REQUEST

Approximately 17.17 acres located on the east side of Providence Rd, south of Jefferson Drive, south of Fairview Rd / Sardis Rd.

STAFF
RECOMMENDATION

Staff recommends approval of this petition upon resolution of outstanding issues related to site and building design and environment.

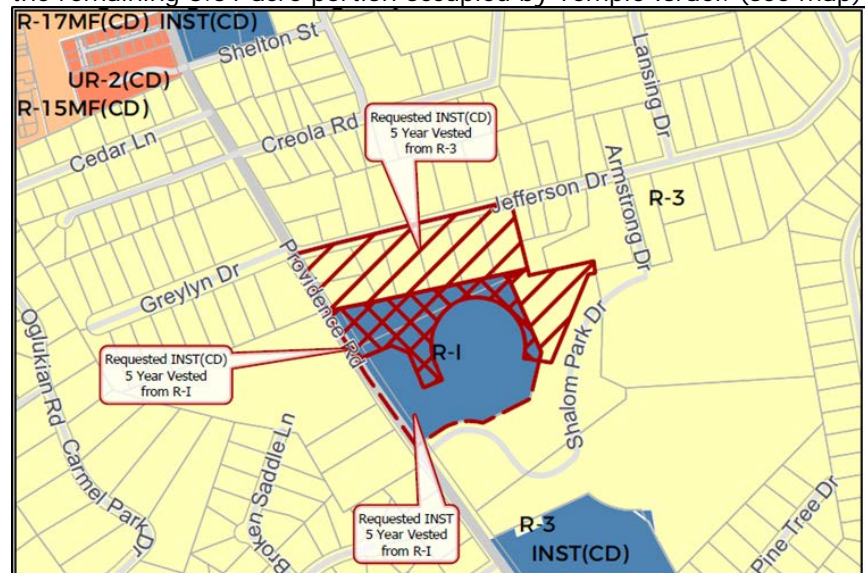
The petition proposes to rezone and redevelop 6 single family dwellings on a 7.51 acre portion of the site to INST(CD) for adult care center/ senior living. Proposes to allow all uses in the INST district for the remaining 3.51 acre portion occupied by Temple Israel. (see map)

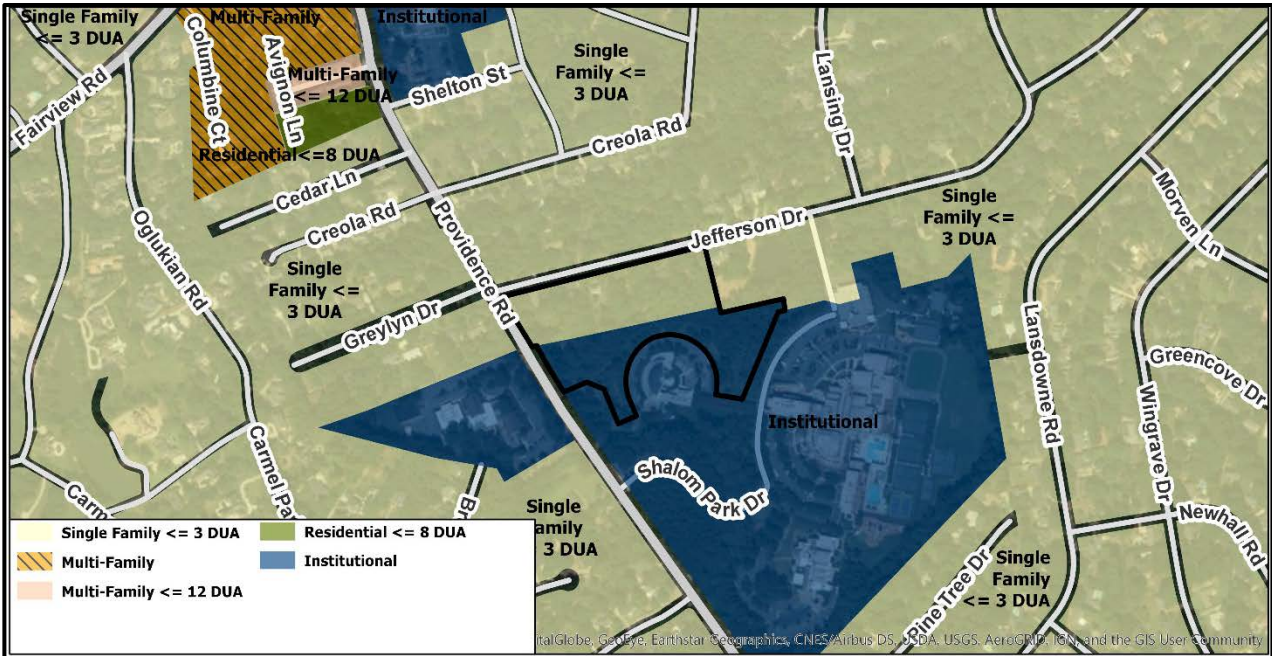
4. Delete the label for “30’ PCO buffer” along the stream and amend the label from the 50’ SWIM buffer to read “50’ SWIM/ PSCO buffer.”
5. Show and label “Potential 30’ PCSO buffer” running northwest to southeast near building 5. See City GIS data below.
